# 1995 - 1996 Corvette: Service Bulletin: Transmission Fluid Leak From Pump Body

**Subject:** Transmission Fluid Leak From Pump Body (Replace Bushing)

**Bulletin Number:** 57-71-26B

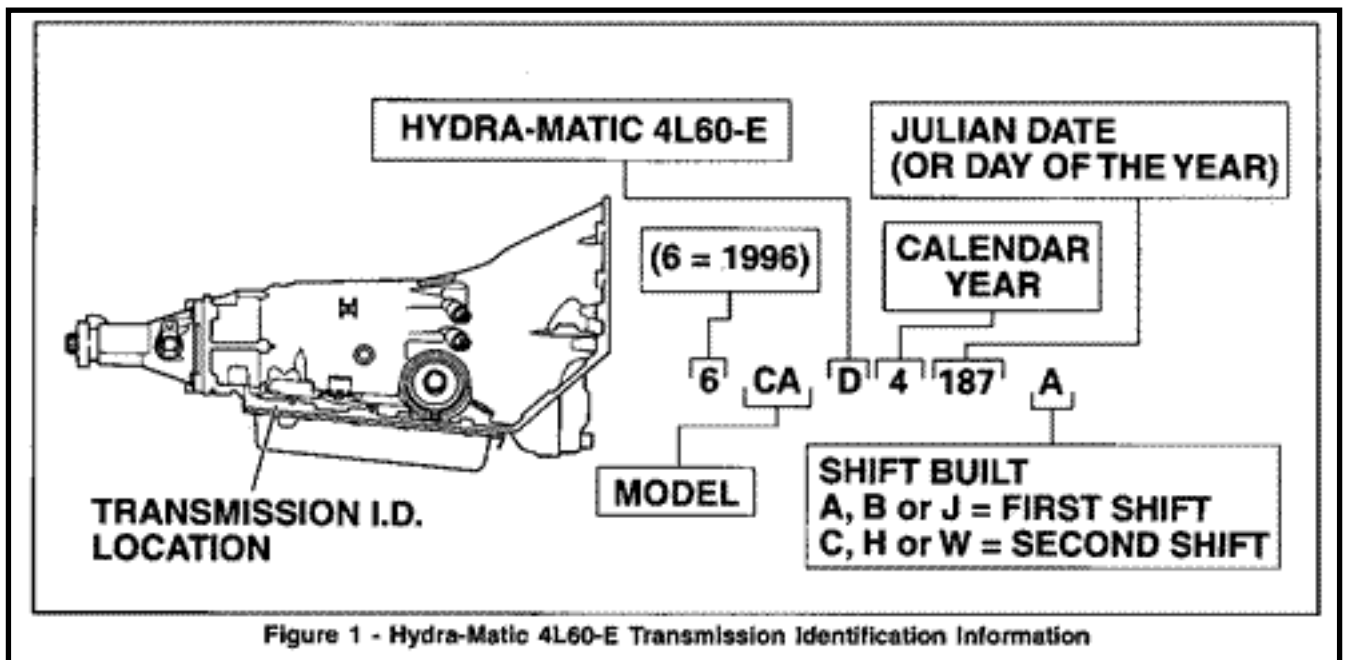
(FIGURE 1) SOME OWNERS MAY EXPERIENCE A PUMP FLUID LEAK. STARTING SEPTEMBER 11, 1995 (JULIAN DATE 254) ALL UNITS ARE BUILT USING A REVISED DESIGN BODY BUSHING.

THE PUMP BUSHING IS SPINNING OR WALKING OUT OF THE BODY.

REPLACE THE PUMP BODY BUSHING USING KENT-MOORE TOOL J41778.

**Figure 2 - Remove Front Helix Retainer**

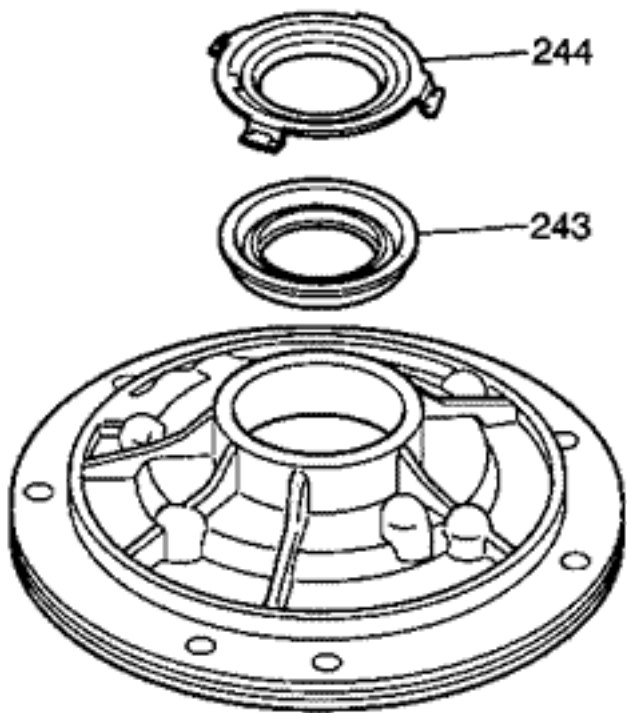
1. REMOVE THE FRONT HELIX RETAINER (244). 2. REMOVE THE OIL SEAL ASSEMBLY (243). 3. REMOVE THE PUMP BODY BUSHING (242) USING TOOL J41778-1. 4. INSTALL NEW BUSHING USING J41778-2 AS A POSITIVE STOP AND AN ARBOR PRESS WITH J41778-1.
